**DRAFT EDIT IN RESPONSE TO USNRC QUESTIONS IN REGARD TO MUTR RELICENSING
DATED January 25, 2005**

**TECHNICAL SPECIFICATIONS
FOR THE
MARYLAND UNIVERSITY TRAINING REACTOR**

License No. R-70

Docket No. 50-166

Figure 6.1: MUTR Position In University Of Maryland Structure

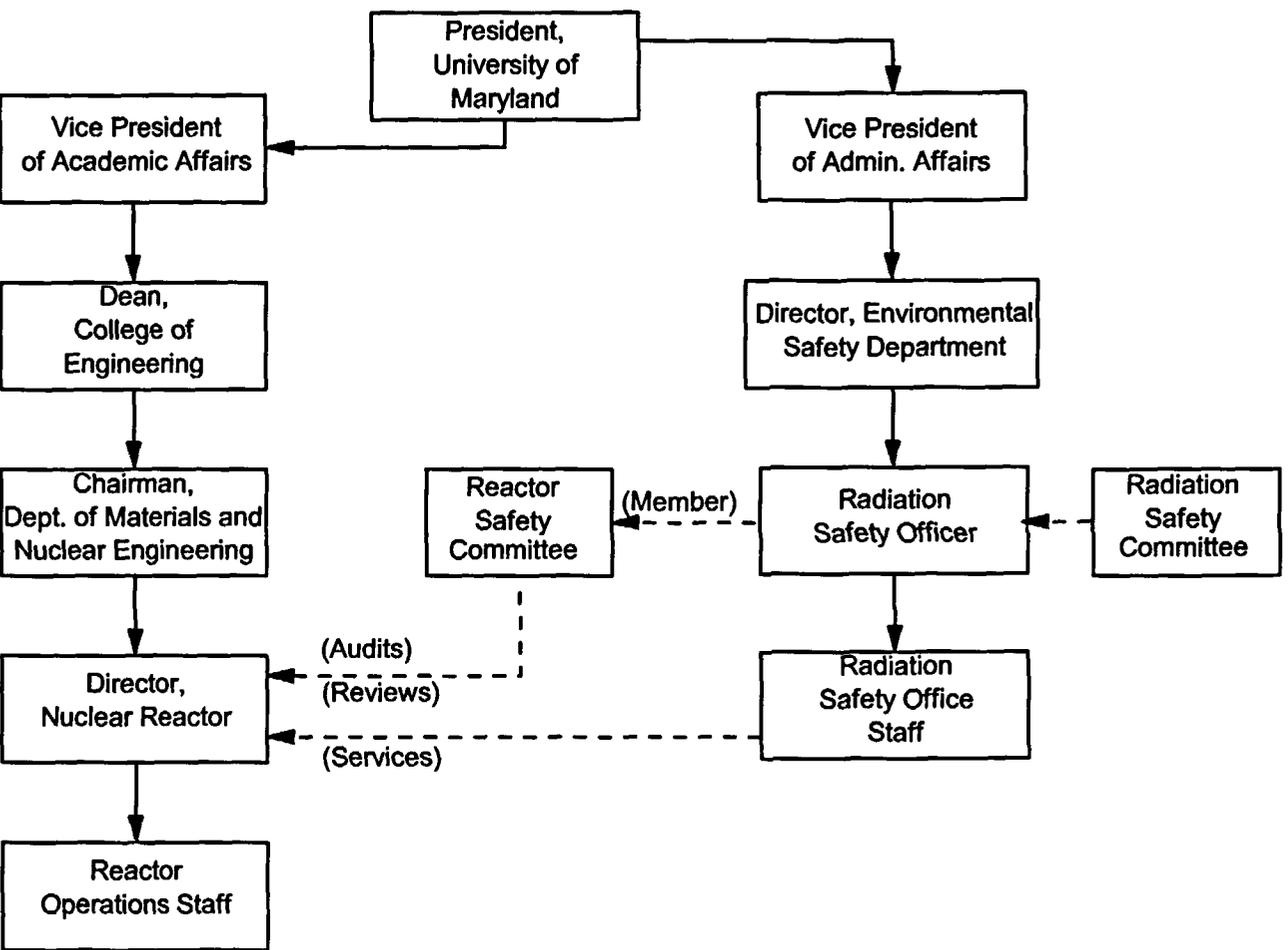
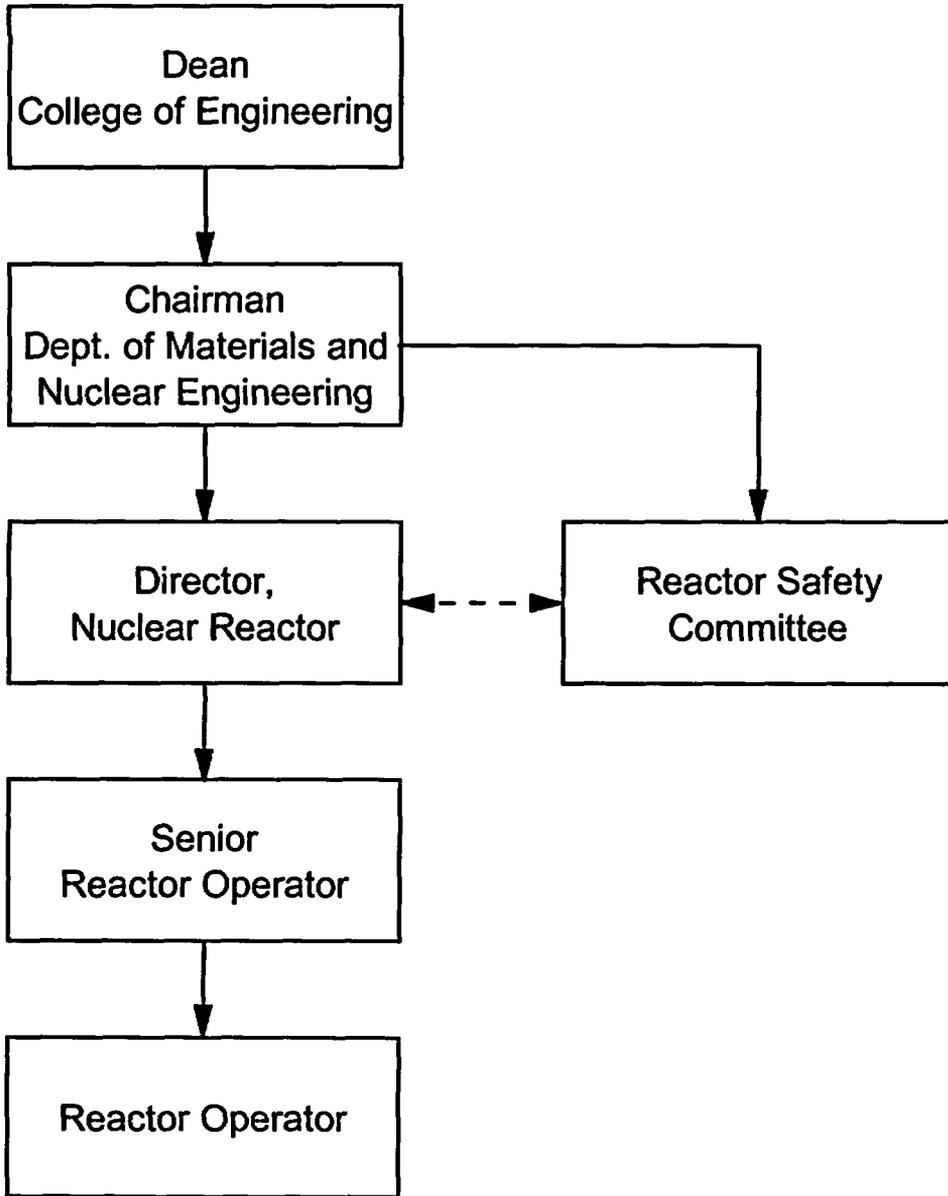
103. TS Figure 6.1 and 6.2. Please clarify the meaning of solid and dotted lines on the structure diagrams. The solid line shown on Figure 6.2 between the Chairman of the Department of Materials and Nuclear Engineering and the Reactor Safety Committee is not on Figure 6.1 (similar comments on SAR Figures 12.1 and 12.2). Please explain.

ATTACHMENT 1: RESPONSE TO QUESTION 84

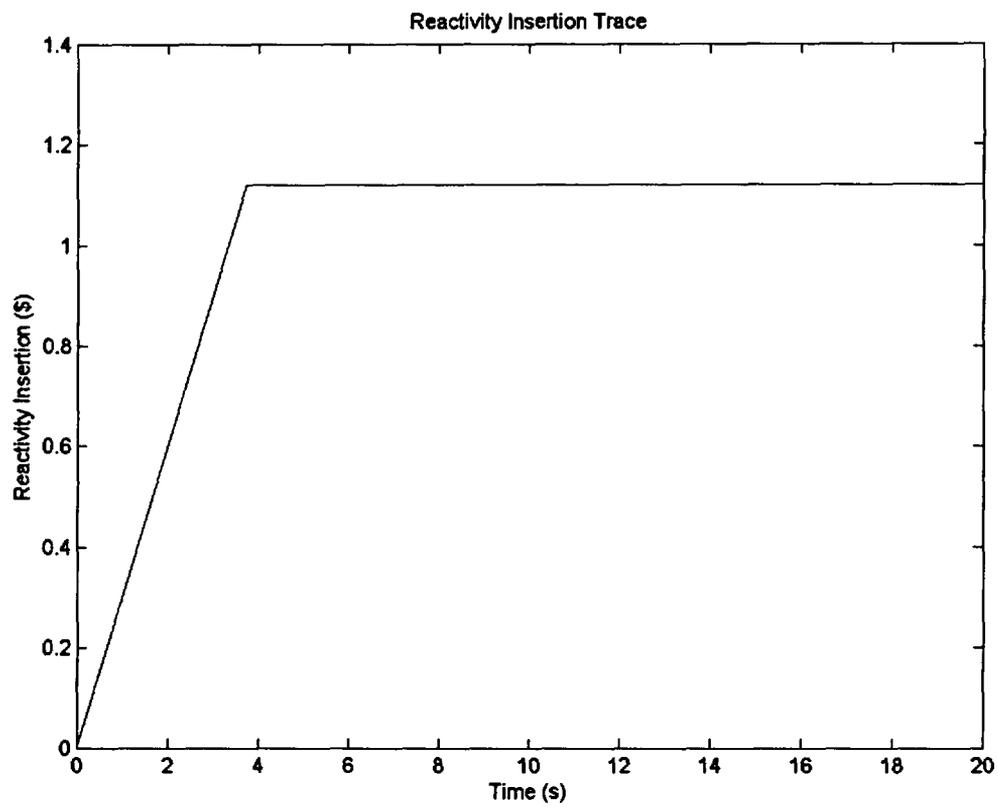
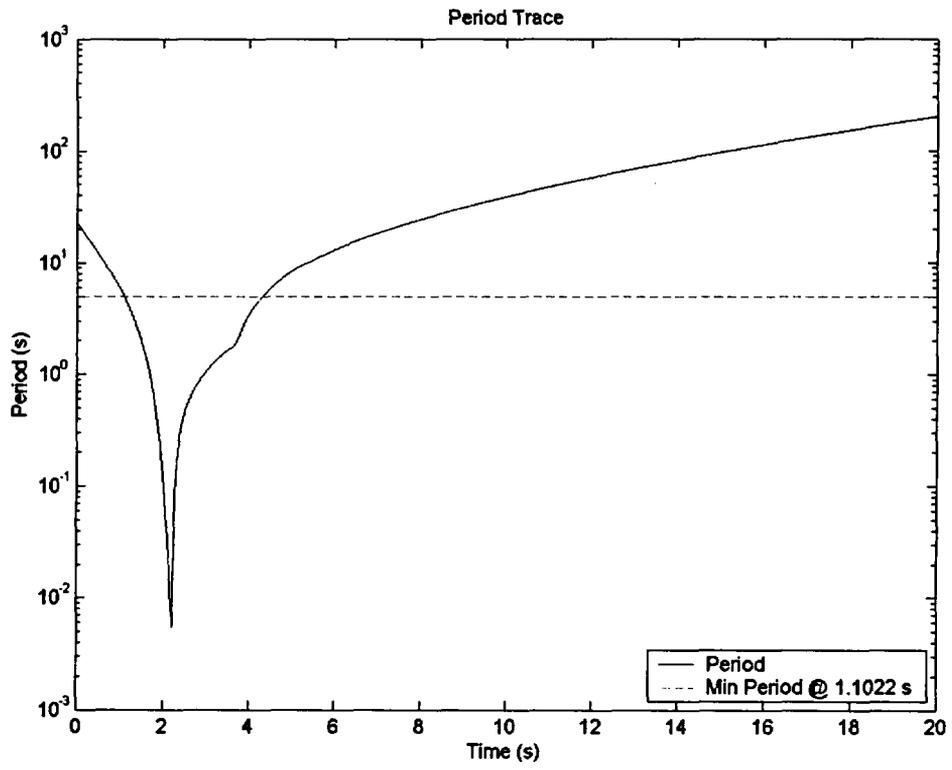
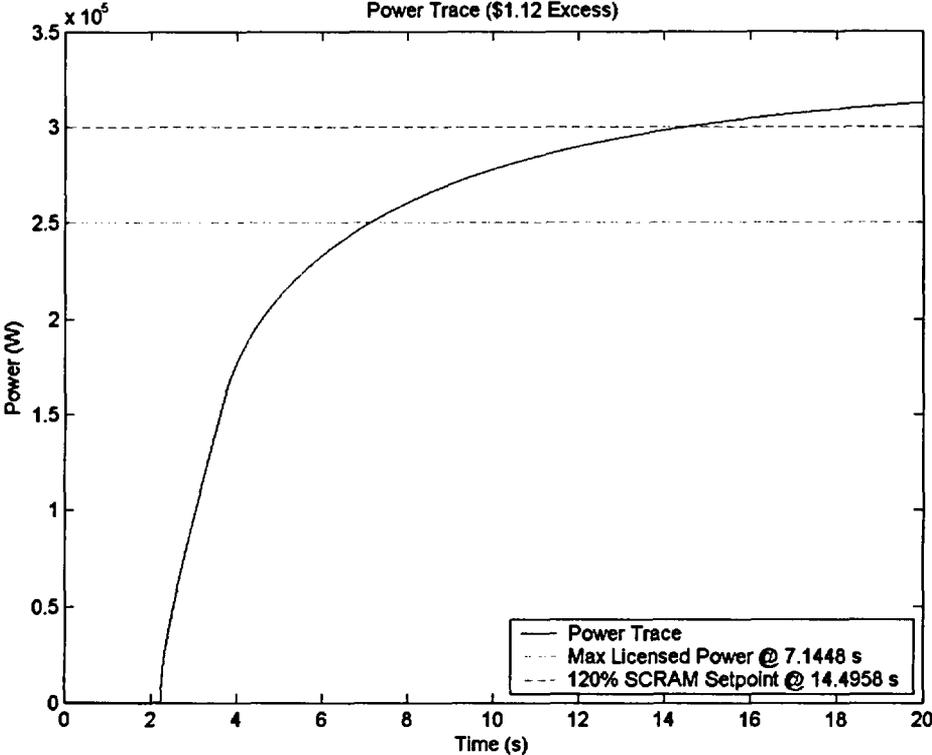
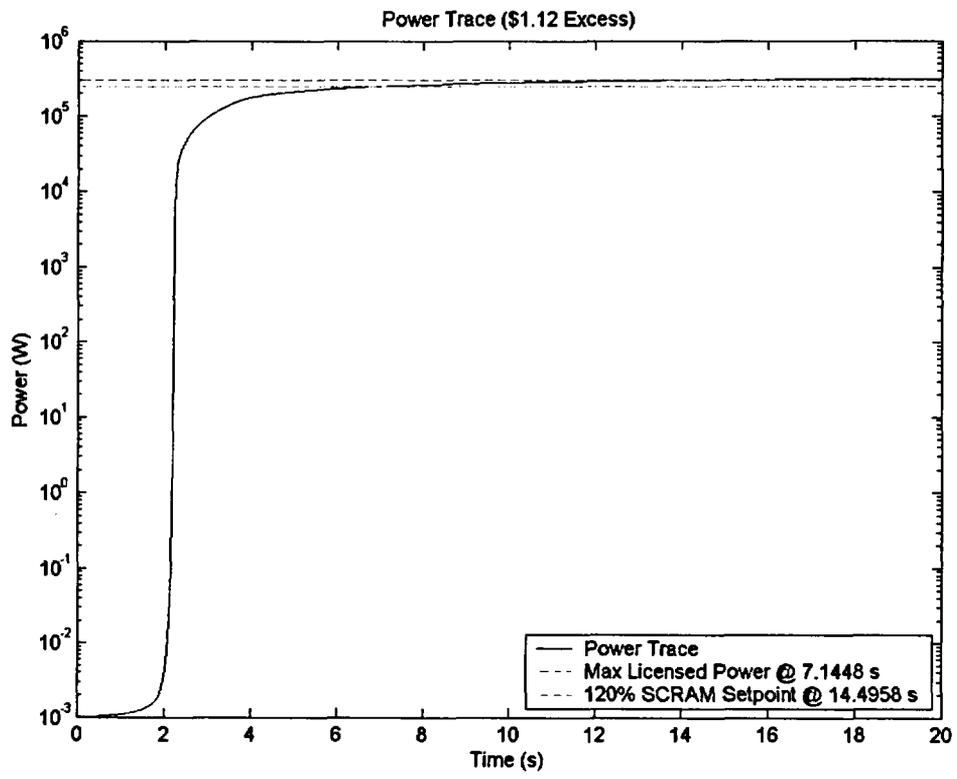
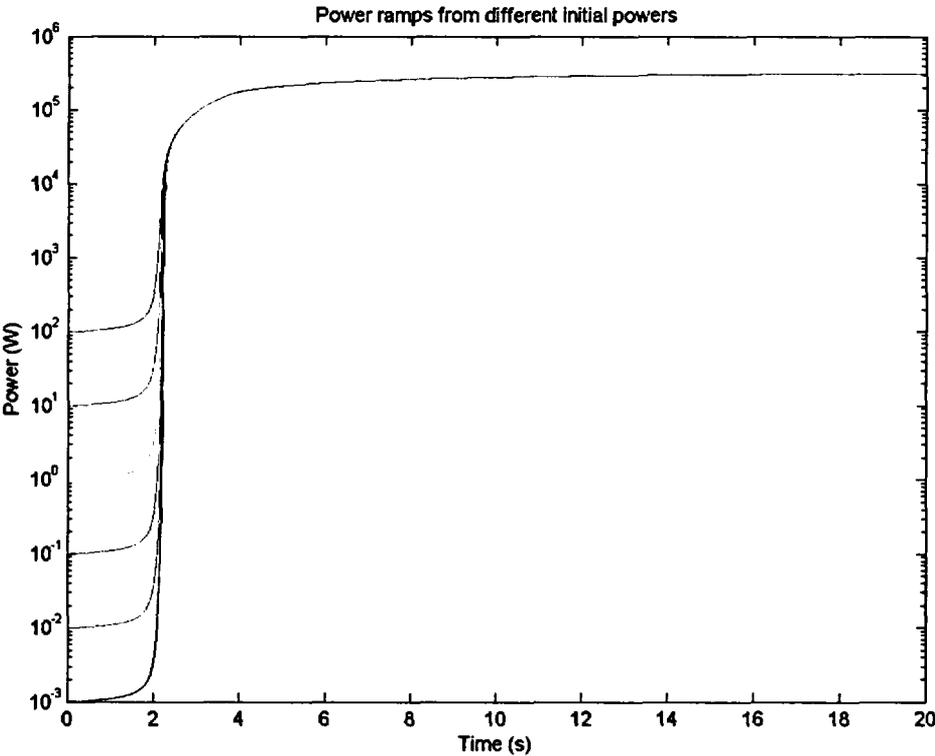
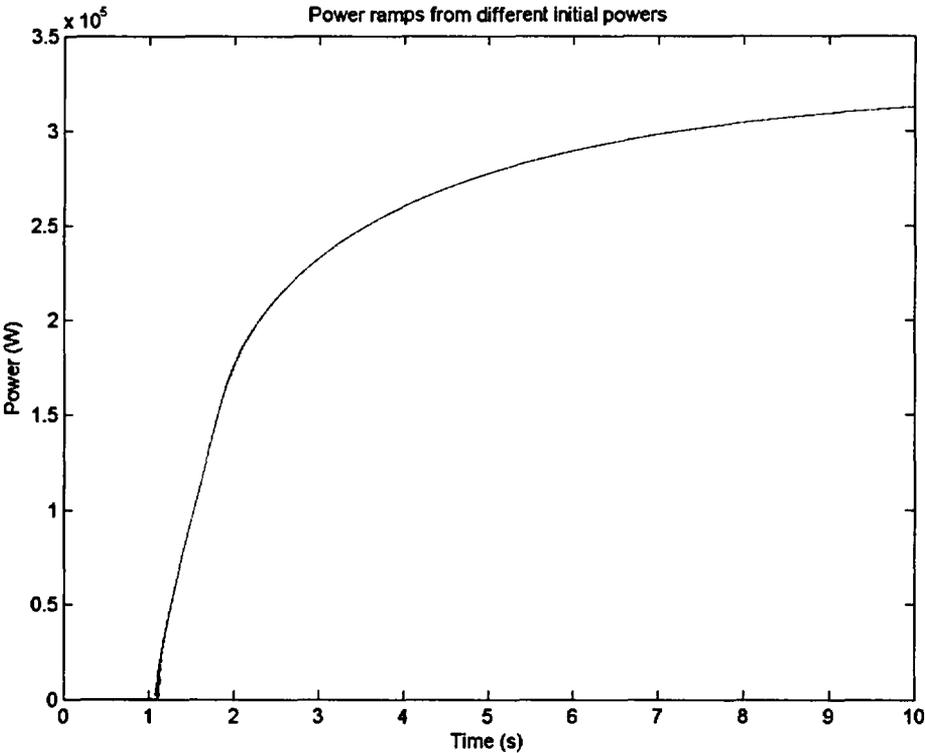
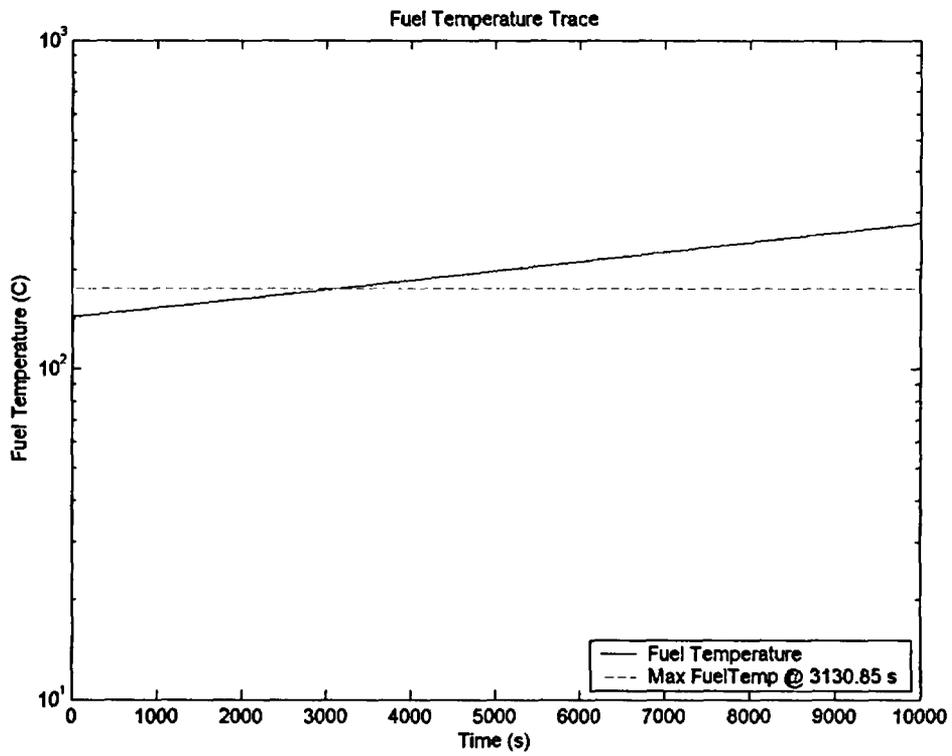
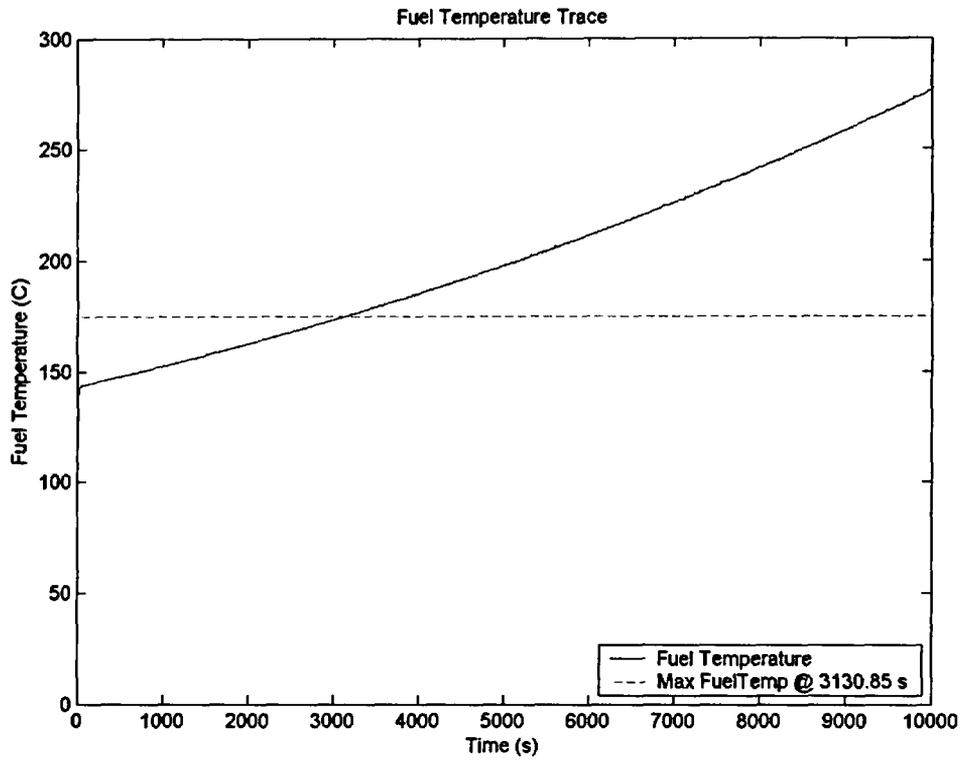
84. TS 3.2.2, REACTOR CONTROL AND SAFETY SYSTEMS. Please discuss the maximum power ramp that would result from adding \$0.30 per second of reactivity to the reactor, starting from a low power condition. Also, discuss the reactor safety system response to the reactivity addition, including power overshoot.

Four scenarios for \$0.30/s insertion will be considered for reactor response with absolutely no human intervention:

The second scenario considered is with a low initial power and with an inoperative period safety system, so that any power fluctuations with a period shorter than 5s are not scrammed. Prompt fuel temperature increases as a result of a sharp increase of power would add controllability, and would lessen the increase in power. Assuming an initial power of 1mW, a \$0.30/s reactivity insertion would finish inserting reactivity after 3.7 seconds (Appendix A), giving the reactor a minimum period of 0.00562s at 2.23s (Appendix B). At this point, the prompt temperature increases have effectively started to remove excess reactivity at a rate of \$0.30/s. The power would continue to rise, which would continue to raise the fuel temperature, until the fuel temperature took away all of the excess reactivity. Eventually, the reactor power would level off. However, there are two independent safety systems, Safety 1 and Safety 2, which would scram the reactor before it got to 120% of full power (300kW). The power would reach 300kW at approximately 14.5s (Appendix C). Assuming the maximum allowed 1s lapse in time from the scram signal occurs before the Control Rods are inserted, and assuming the full negative reactivity of the Control Rods is inserted instantly, the power would rise to maximum of 303.15kW before dropping down to 153.6kW in a prompt drop and then exponentially decaying with a negative 80s period.

The first and second scenarios were considered with an initial power of 1mW. Simulations were done for several initial powers. According to the results, regardless of the initial power, as long as it is below the point of adding heat, the powers will converge to a power trace that levels off and then slowly increases as the moderator is heated up, adding excess reactivity (Appendix D).

The third scenario considered is with a high initial power, and with either of the Safety 1 or Safety 2 safety systems in working order, scrambling any power that is greater that or equal to 120% of full power (300kW). This is also a realistic scenario, as both independent systems are robust and have been consistent in their operation. As the initial power increases, the initial fuel temperature also increases, which lowers the excess reactivity. Therefore, this scenario is more realistic than the second, as there is insufficient reactivity to obtain a period shorter than 5s. The period scram setpoint does not come into play in this scenario. The power simply

converges to the low initial power trace, and then scrams at 120% of full power. The scram time will change depending on what the initial power is.
